CONTRACT AMENDMENT

This Amendment (the "Amendment") is made this 21st day of February 2022 by and between:

JOHNSON CONTROLS, INC. ("JCI")
6 AERIAL WAY
SYOSSET, NY 11791

BAYPORT-BLUE POINT SCHOOL DISTRICT ("CUSTOMER" or the "District")
189 ACADEMY STREET
BAYPORT, NY 11705

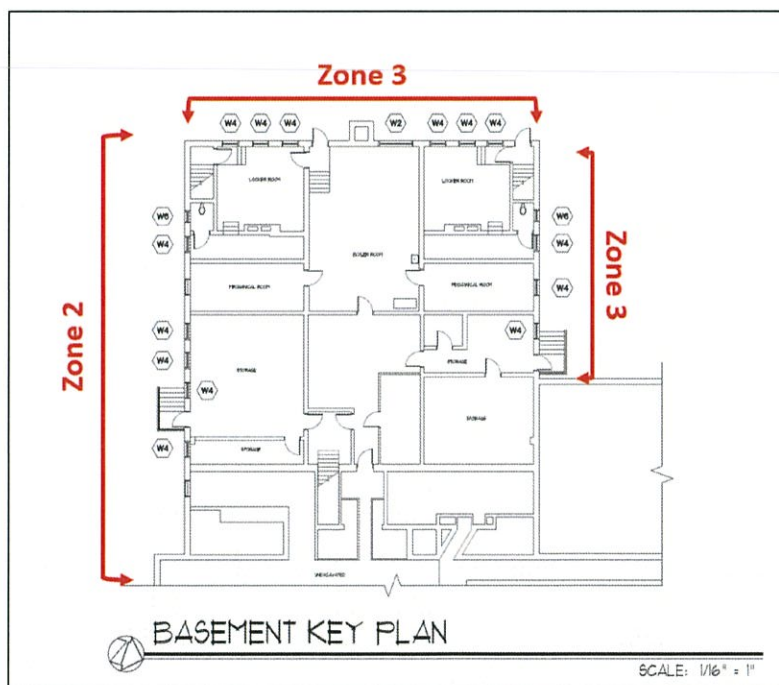
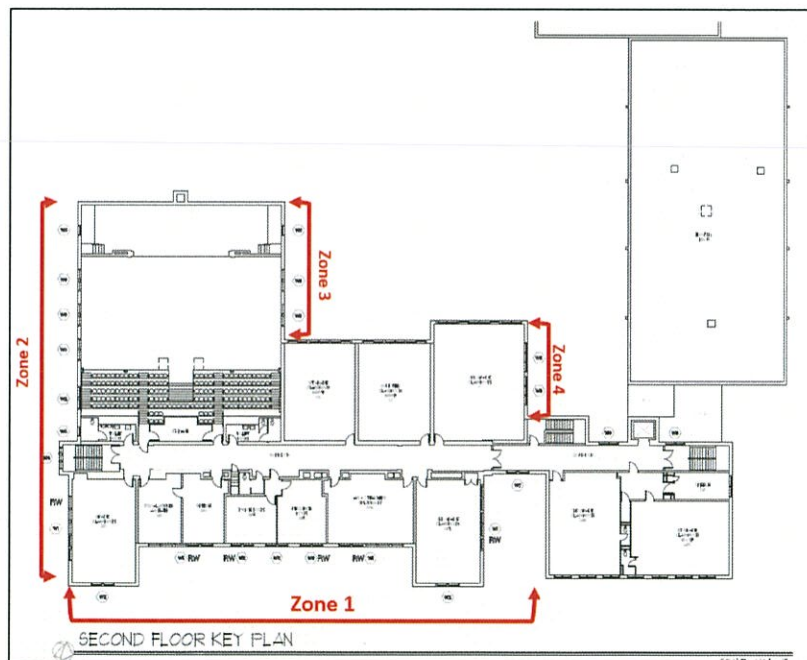
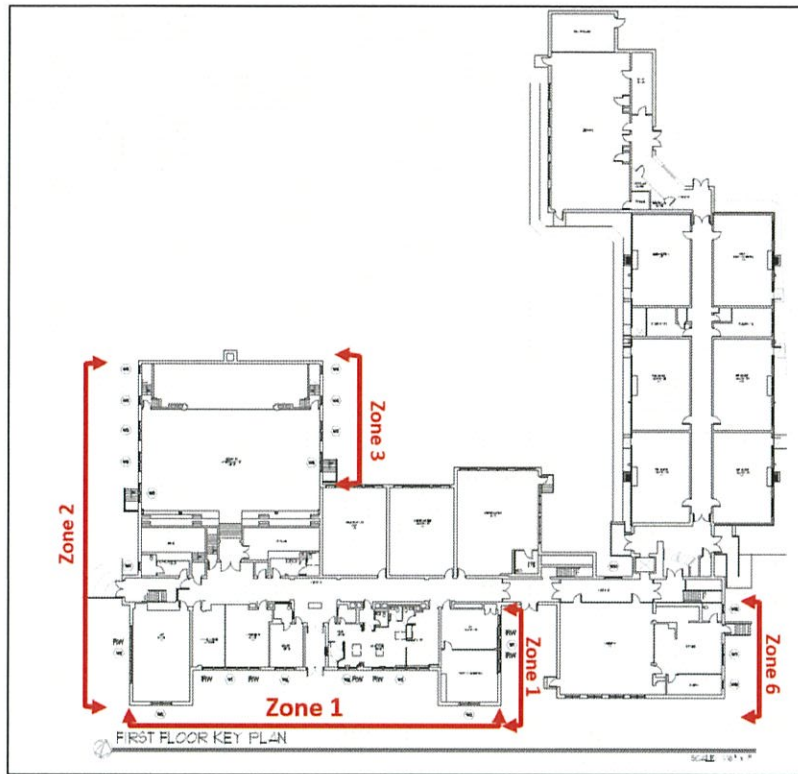
- g. On Page 39 of the Agreement, under ECM 6: Windows & Doors Replacement, remove the scope in its entirety and replace with the following:

Johnson Controls will furnish and install new exterior double pane energy efficient windows and new exterior energy efficient Fiber Reinforced plastic FRP style doors listed below as per the NYS Energy Code in effect at the time of contract signing.

- Replace Cafeteria Exit Doors

Blue Point Elementary School

- Replace West 1954/63 Windows
- Replace Gym Windows
- Replace Corridor Windows

The areas for the window replacements are shown in the picture below.

The windows shall be Traco single hung windows. The doors shall be Vale FRP doors with Stanley/Best hardware including closers, hinges, panic bars, cylinders and saddles.
